A modified Fig 31B-1

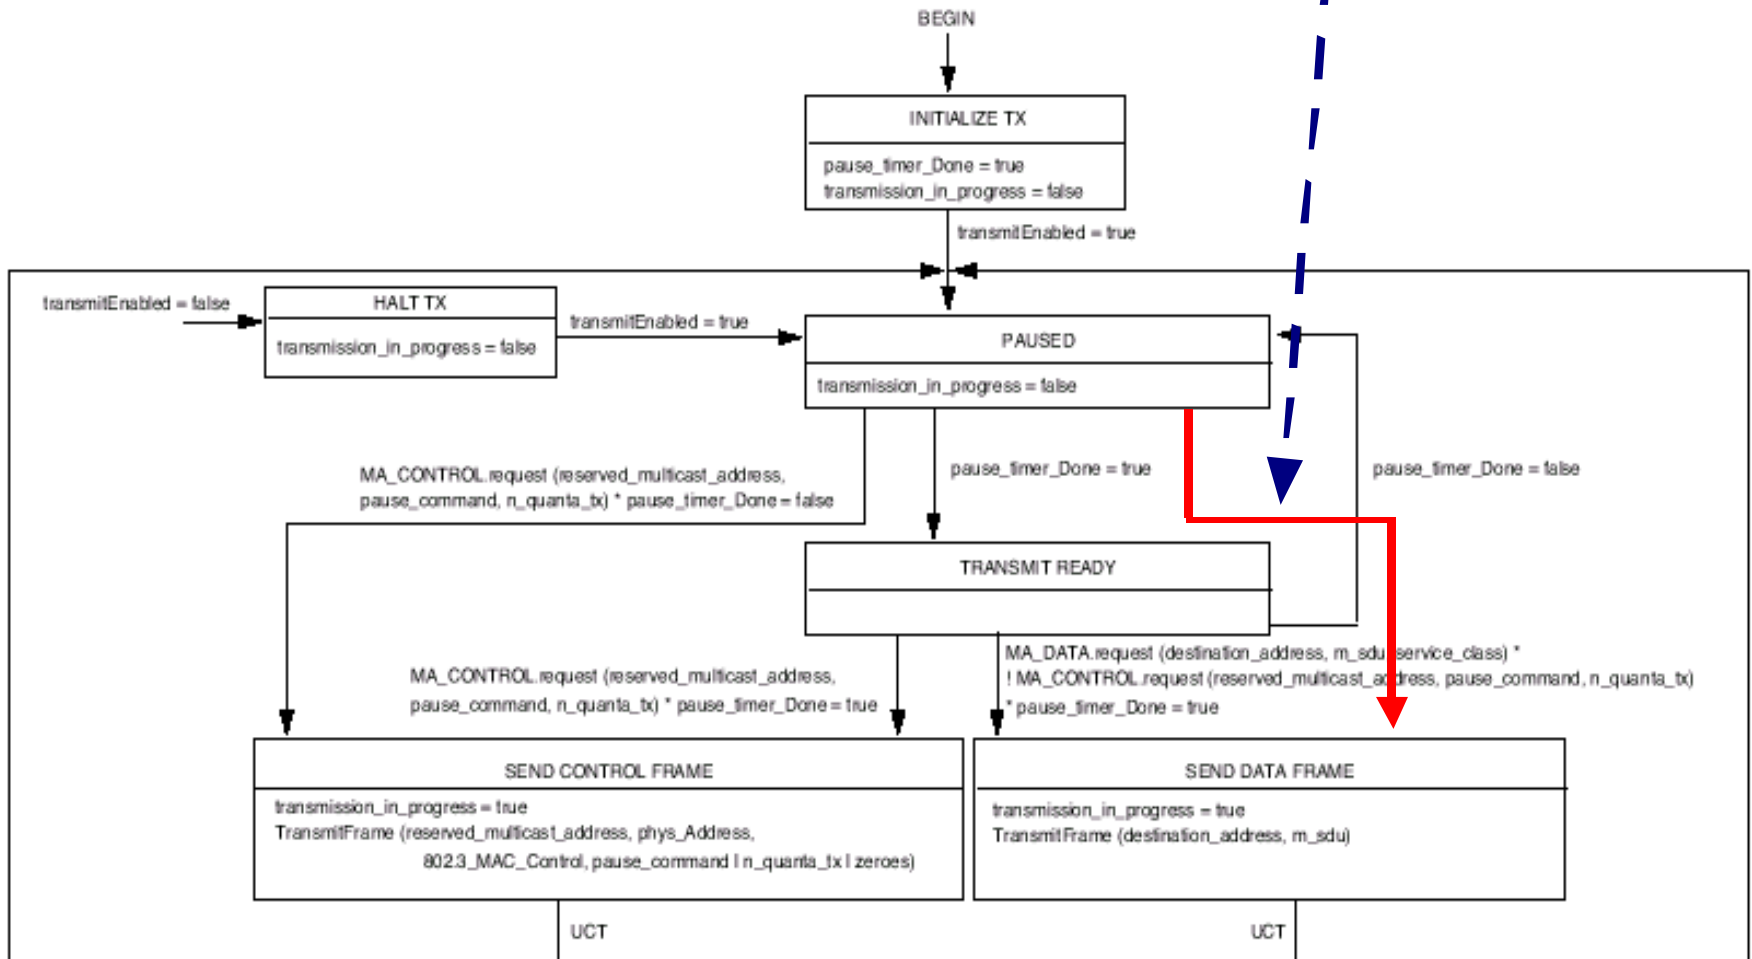
MA_DATA.request(DA, m_sdu) *
 (type=88 - 09)*(subtype=OAM)
